Docket Number:	09-AFC-08C
Project Title:	Genesis Solar Energy Project
TN #:	266238
Document Title:	Petition to amend-Hydrogen removal equipment
Description:	N/A
Filer:	Cynthia Keller
Organization:	NexteraEnergy Resources
Submitter Role:	Applicant
Submission Date:	9/30/2025 2:10:00 PM
Docketed Date:	9/30/2025

Petition to Amend

By this amendment Genesis Solar, LLC, petitions the Commission to consider the stated Condition of Certification to add a HyMATE Unit provided by CSP Services) to each HTF system in Power Block Unit 1 and Unit 2.

Figure 1: Proposed HyMATE system location in the Genesis power blocks

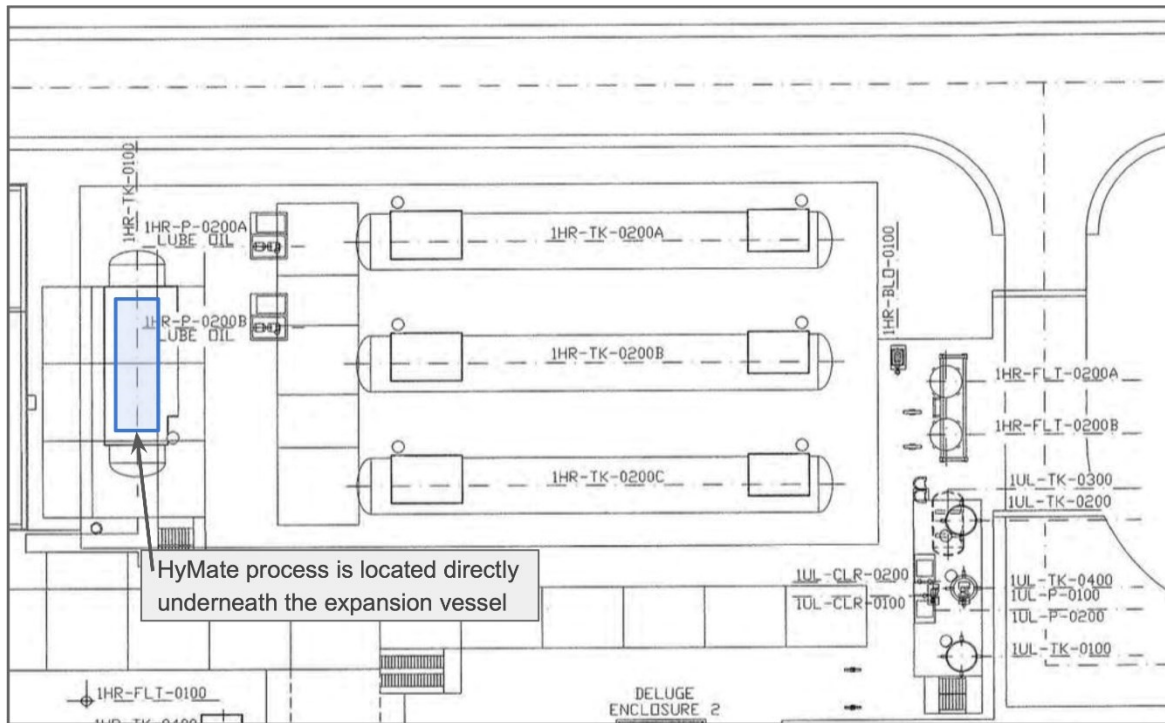
The location of the HyMATE process is shown in Figure 1 and is directly under the EV. This area (Figures 2, 3) is covered with a concrete pad, has close proximity to the EV, and has ample height and width clearance. These features make this location best suited for installation of the HyMATE process. The location is accessible from the adjacent paved road. The HyMATE process will be unloaded from a flatbed truck and positioned onto the concrete pad using a forklift or crane.
